INSTALLATION PICTURE ILLUSTRATIONS

Replacement Discontinued 830 ~~A~~ HU with the 864 TEC Series Hinges

864
Cup Hole
830

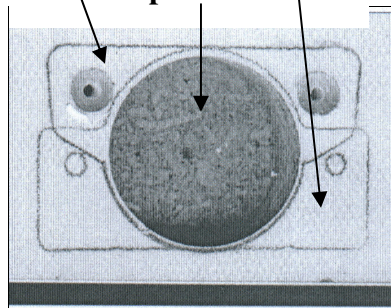
Note: The 864 hinge will fit in the same cup hole, but the screw hole pattern in the door is different. The cup will not cover the 830 mounting screw hole pattern, but will function the same. If the new hinges have plastic dowels, remove if necessary. Fill the holes that are exposed with wood putty. Pre-drill new holes with a 3/32" bit. Be sure not to drill deeper than 7/16" so that it will not go through the front of the door. When door is removed, replace all hinges on that door with new hinges of the same type. The screw holes on the baseplate will fit the existing screw holes on the frame.

Make sure the cups are straight when pre-drilling cup mounting screw holes.
